STAFF RECOMMENDATION
1718 Greenwood Avenue
March 16, 2016

Application: Alteration to permit
District: Eastwood Neighborhood Conservation Zoning Overlay
Council District: 06
Map and Parcel Number: 08302027500
Applicant: Urban Development Group, LLC
Project Lead: Melissa Baldock, melissa.baldock@nashville.gov

Description of Project: Application is to alter the existing permit for infill with a front yard parking pad.

Figure 1. 1718 Greenwood Avenue

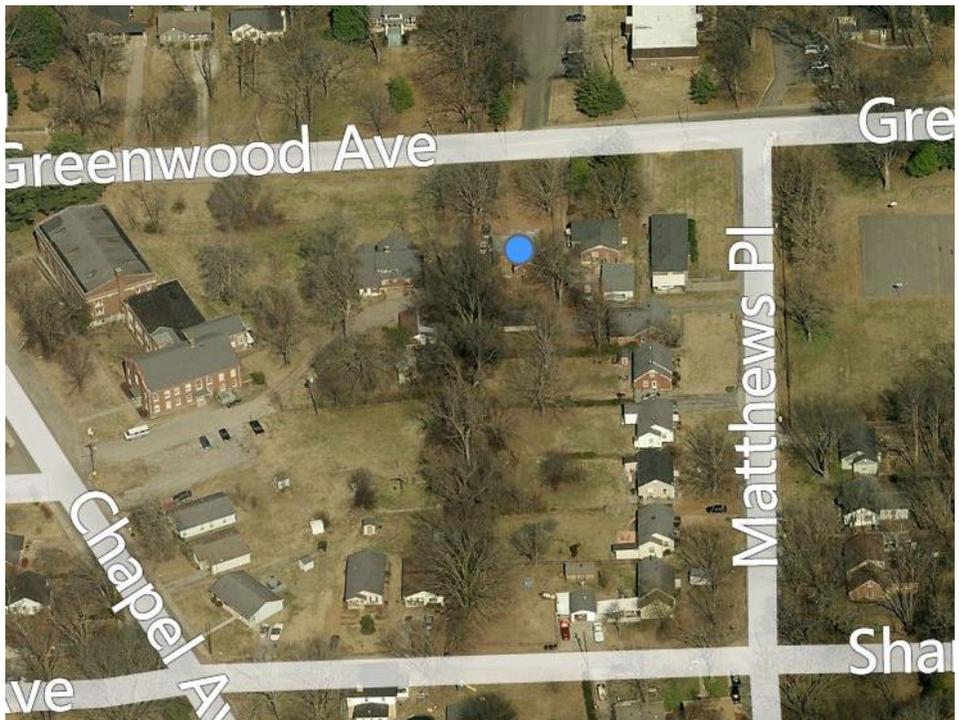
Background: In February 2015, the Metro Historic Zoning Commission approved the construction of duplex infill at 1718 Greenwood Avenue (Figure 1). The infill has a deep front yard setback, which matches the front setback of the adjoining houses. There is no alley access for the site.

Figure 2. The site plan approved by MHZC in 2015.

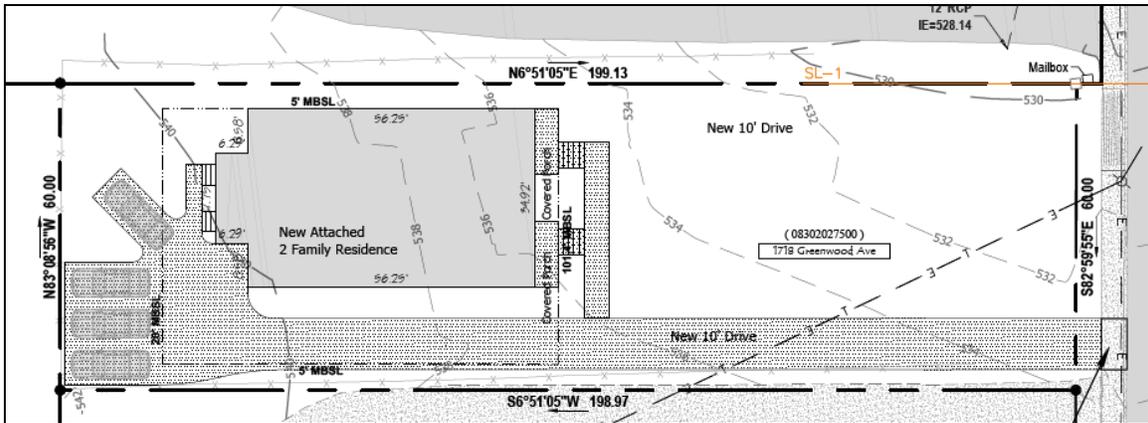
The site plan the Commission approved provided for four parking spaces (two for each duplex unit) at the rear of the site (Figure 2). However, a retaining wall was constructed

approximately six to ten feet (6'-10') off of the left side property line, and approximately four feet (4') off the rear property line. The retaining wall in this location reduced the area in the rear for parking (Figures 3 – 6).

If the retaining wall were to be moved back to its original location, staff believes there would be enough room for the original four rear parking pads. Staff therefore finds that the proposed front yard parking pad does not meet the design guidelines or the historic context of the Eastwood neighborhood.

Figure 7. Proposed parking plan for the duplex.

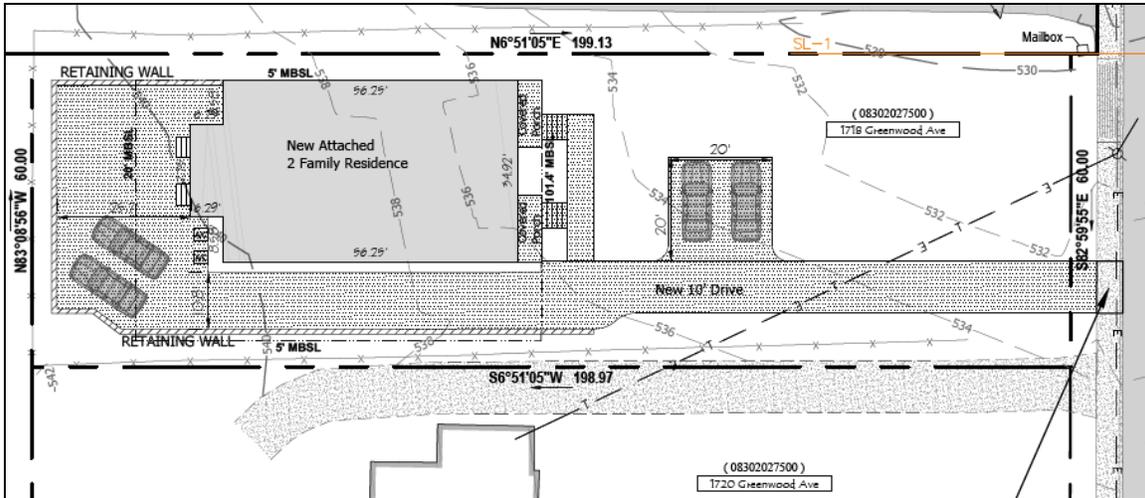
Orientation: The applicant is proposing parking for two cars in the rear of the property, behind the house, and for two other cars in the front yard, accessed via the existing driveway and curb cut (Figure 7). The front yard parking pad will be twenty feet by twenty feet (20' X 20') and will be located in front of the house. It will be located approximately sixty feet (60') from the front property line and will be approximately twenty-three feet (23') from the infill's front porch.

The design guidelines require that a building's front façade be visually consistent with the surrounding historic properties. Because other buildings with similar setbacks have parking at the rear, staff finds that cars parked in the front yard will change the look of the front façade in a manner that would not be within keeping with the historic context. This is consistent with the Commission's past decisions which are clarified in the italicized language which state that "*Front yard parking or driveways which end at the front of the house are not consistent with the character of the historic neighborhoods.*"

Staff recommends disapproval of the proposed front yard parking plan, and recommends that the applicant provide parking for four vehicles behind the historic house, even if that requires the relocation of the retaining wall.
